1. Type of Well  Gas Well Gas Well Ott	her		· 8. Well Name a HAMBONE	nd No. FEE COM 1H
2. Name of Operator COG OPERATING LLC		BRIAN MAIORINO	9. API Well No 30-015-38	5. 980-00-S1
3a. Address ONE CONCHO CENTER 60 MIDLAND, TX 79701	0 W ILLINOIS AVENUE	3b. Phone No. (include area code Ph: 432-221-0467	10. Field and P BRUSHY	ool, or Exploratory DRAW

4. Location of Well (Footage, Sec., 7	T., R., M., or Survey Description)	,	11. County or I	Parish, and State
Sec 5 T26S R29E SWSW Lot	t M 660FSL 330FWL		EDDY CO	UNTY, NM

## Hambone Fee Com 1H 30-015-38980 COG Operating LLC May 08, 2014 Conditions of Approval

CONC	10			
Author:	Stroup			
Well Name	Hambone Fee	Well No.	#1H	
Field	Rockspur: BS	API#:	30-015-38980	
County	Eddy	Prop #:		
State	NM	Zone:	Avalon Shale	
Date	10/10/2013			
GL	2906'	,		
KB.	2924'

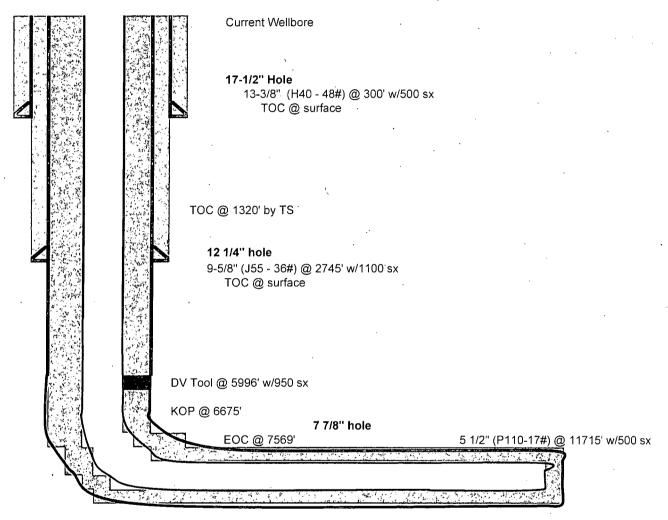
- 1. Operator shall place a balanced Class C Cement plug from 6,725'-6,425' to seal the top of the Bone Spring formation and lateral.
- 2. Operator shall place a balanced Class C Cement plug from 6,046'-5,946' to cover the DV tool at 5,996'. WOC. Tag.

- 3. Must conduct a casing integrity test before perforating and fracturing. Submit results to BLM. The CIT is to be performed on the production casing to max treating pressure. Notify BLM if test fails.
